**Response to Comments
on
EPA Draft 2020 Permit Modification to the 2016 Reissued RCRA Permit and
Associated Statement of Basis for EPA’s Remedial Action for the “Rest of River”
Portion of the Housatonic River**

GE-Pittsfield/Housatonic River Site

December 2020

U.S. Environmental Protection Agency
Region 1 (EPA New England)

**GE-Pittsfield/Housatonic River Site,
 Rest of River
 FIGURE 3
 OPCA AND ALLENDALE SCHOOL
 PCB AIR MONITORING
 LOCATIONS**

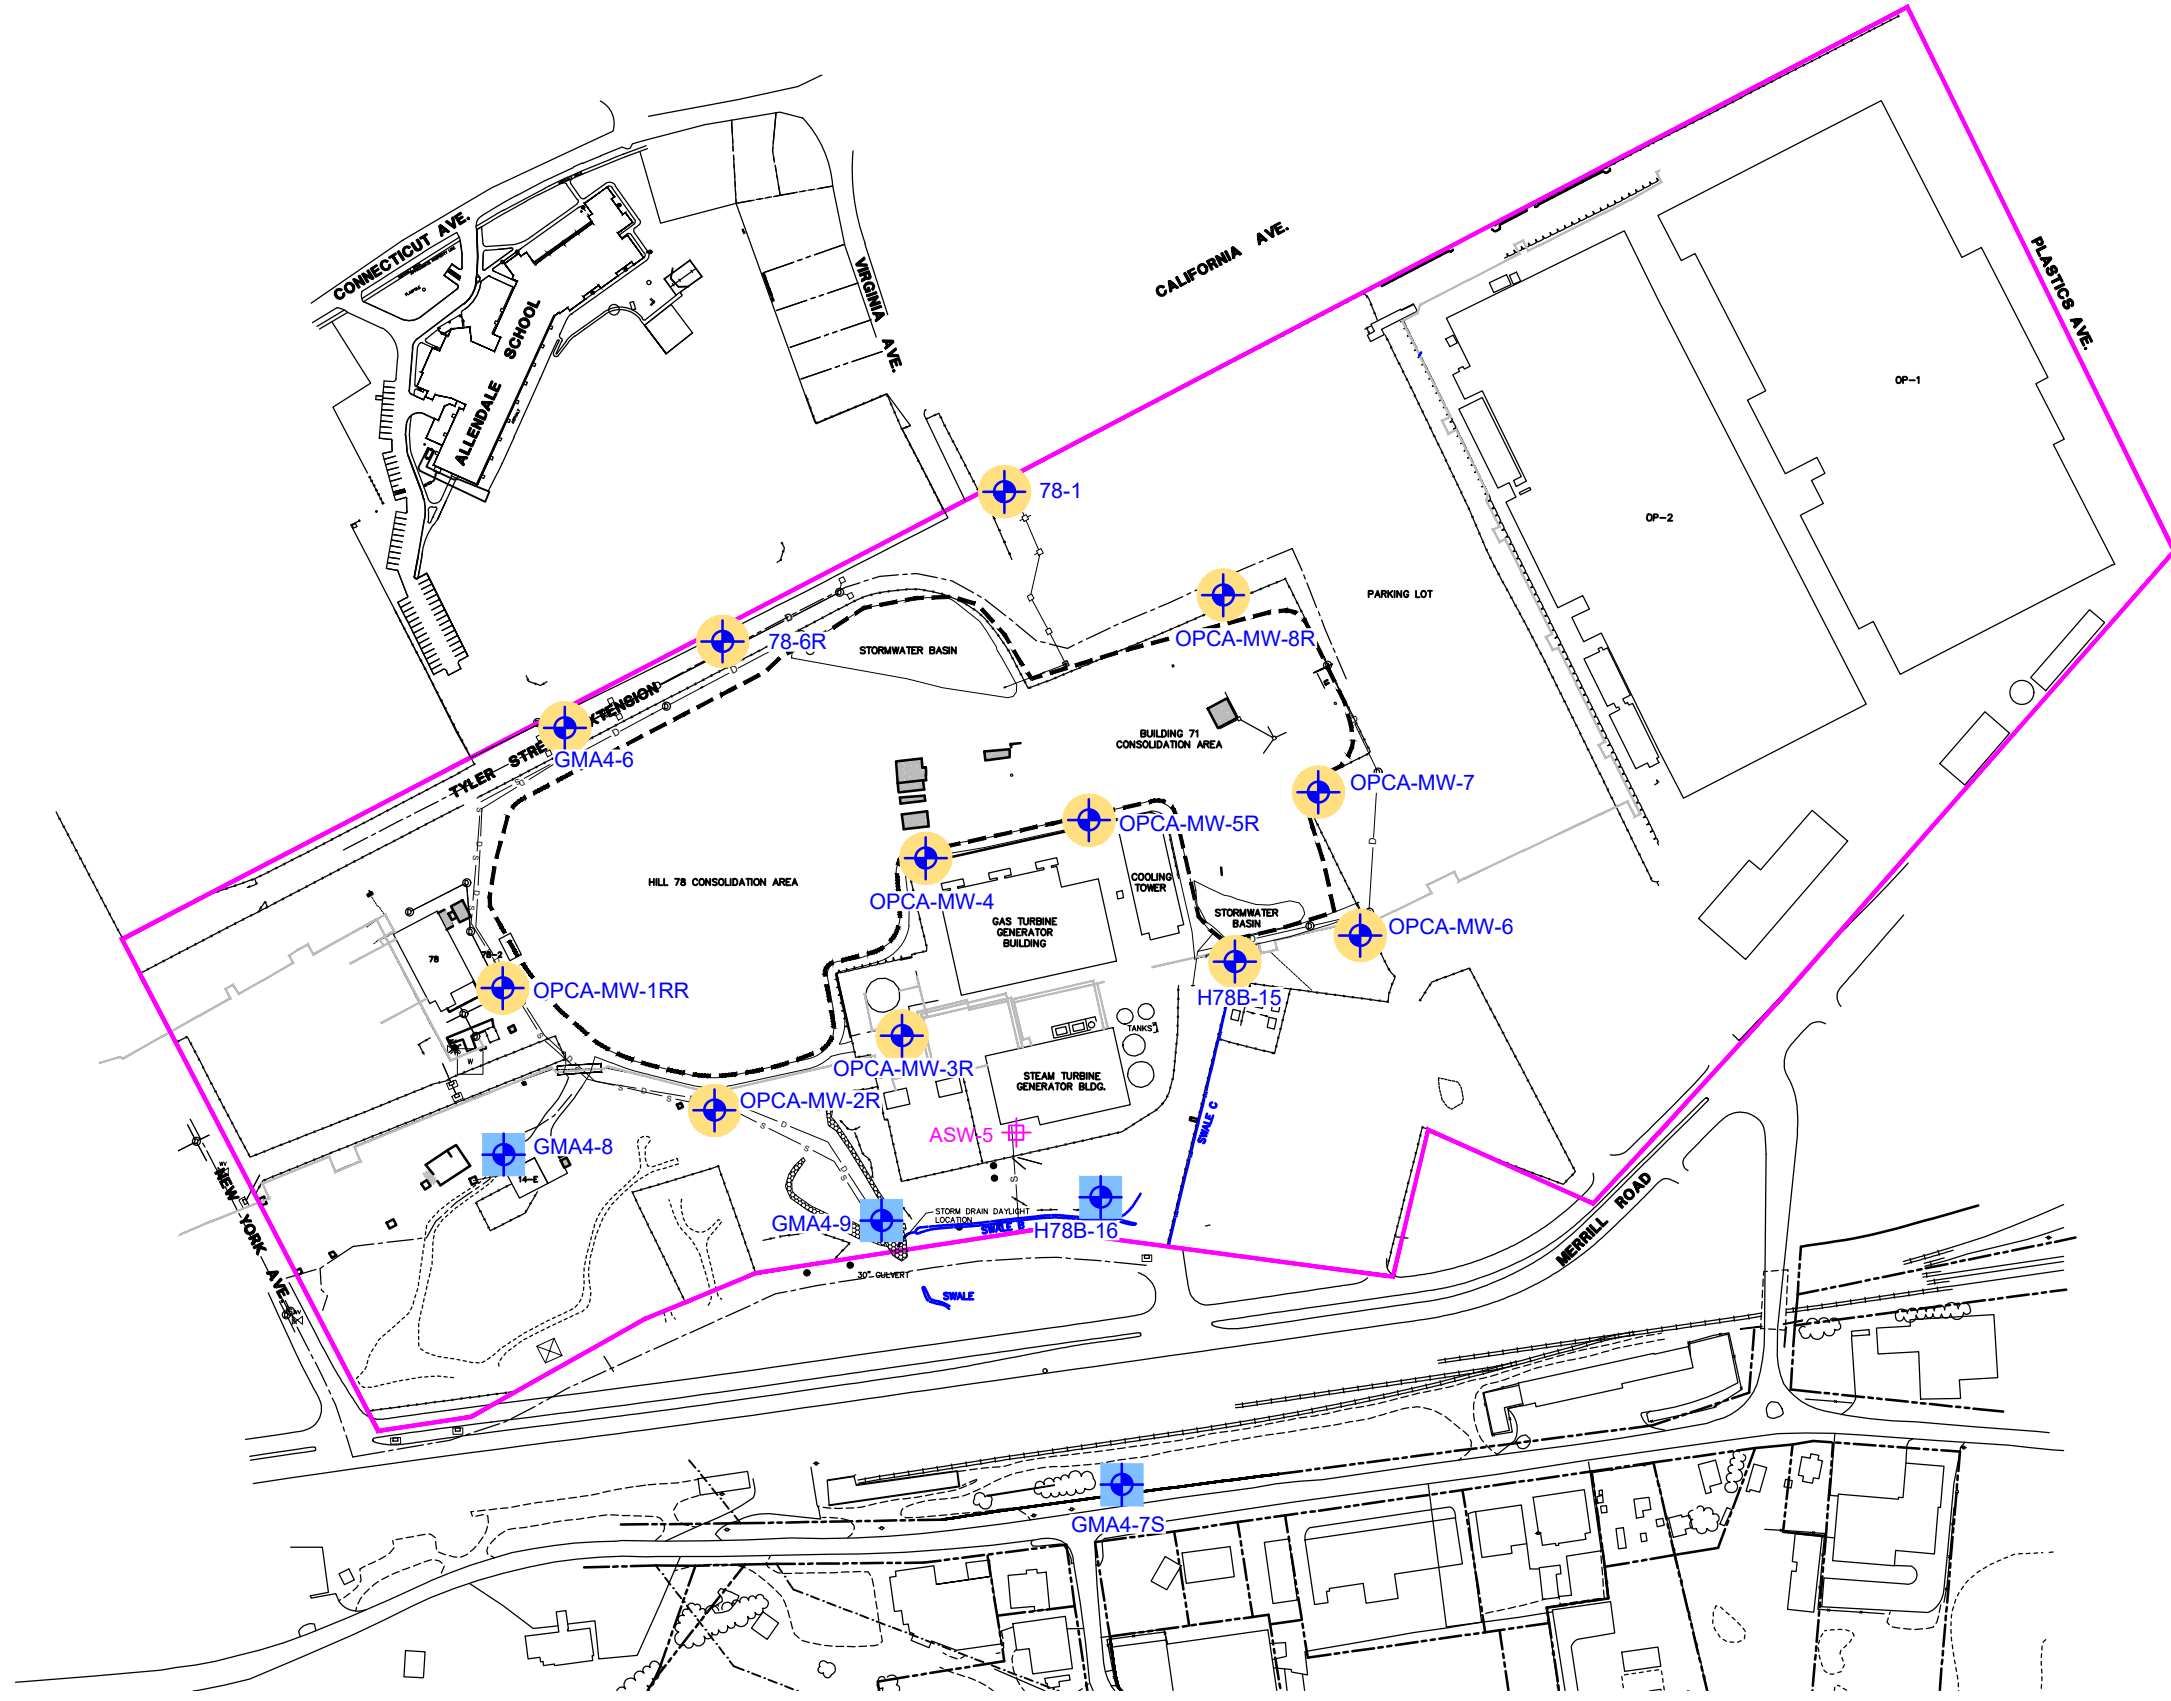
Comment II.A.3: Several commenters expressed concerns that the proposed UDF is similar to the landfills/OPCAs constructed in Pittsfield as part of the Consent Decree and that in the commenters' view, the landfills/OPCAs are leaking or are otherwise not safe.

At the onset of consolidation activities in 1999, EPA required that GE monitor the air surrounding the OPCAs at five air monitoring stations. Figure 3 presents the current OPCA air monitoring locations. These locations are on GE property and are all within a maximum of 250 feet of the OPCA disposal areas. In 1999, the Region set a site-specific notification level of a 24-hour average of 0.05 micrograms (μg) PCBs per cubic meter of air ($\mu\text{g}/\text{m}^3$) and an action level of $0.100 \mu\text{g}/\text{m}^3$. If a notification level was exceeded, GE was required to notify EPA as soon as practicable, but no later than 24 hours after receipt of the data showing such an

**FIGURE 7
SURFACE WATER ELEVATIONS
AND WATERSHED SUBBASINS**

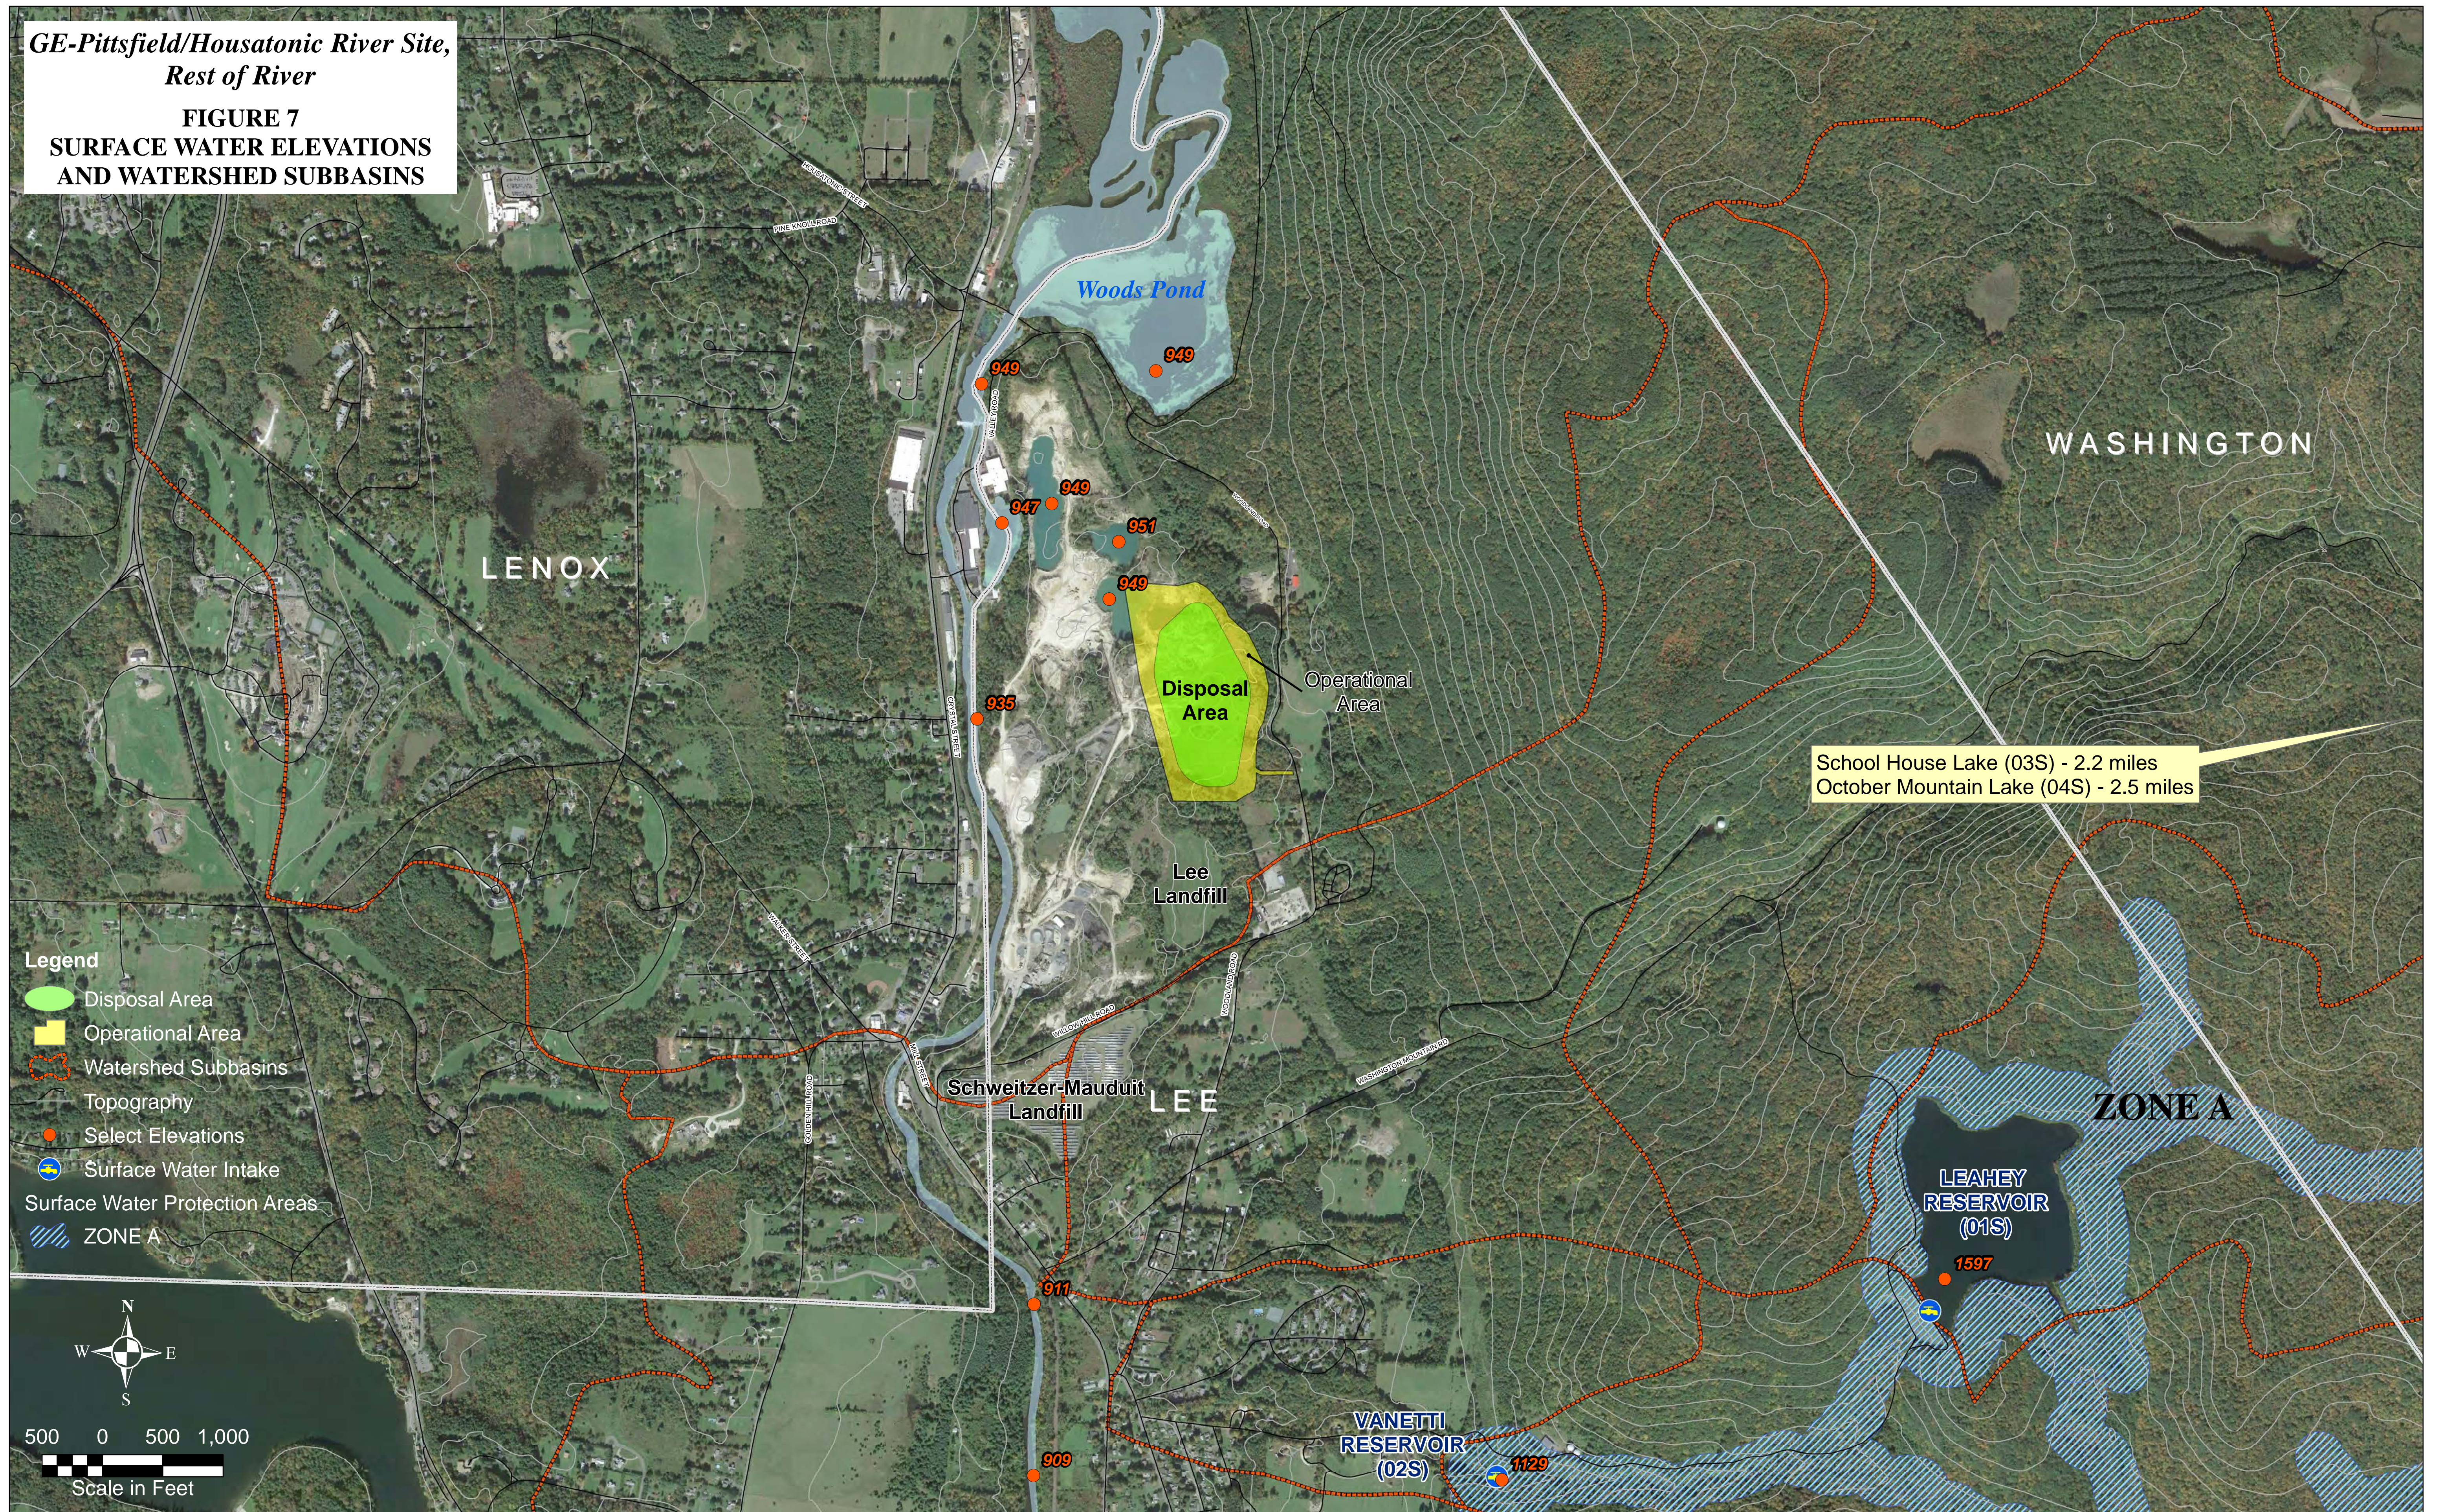
Comment II.A.5: Several commenters expressed concerns about impacts to local water supplies should a release occur. A number of commenters questioned the provisions for abandonment of

reservoirs. 2018 Post-Closure Environmental Monitoring Report, Schweitzer-Mauduit International, Inc. Willow Hill Road Landfill, C.T. Male Associates to DEP, June 11, 2018; CDM figure titled “Town of Lee Sanitary Landfill, Bedrock and Overburden Contours, January 30, 1995.” Figure 9. In addition, based on surface water elevations, the expected groundwater flow is generally east to west—from the UDF towards the Housatonic River, and similarly, from the Town of Lee reservoirs westerly towards the River. Figure 7.
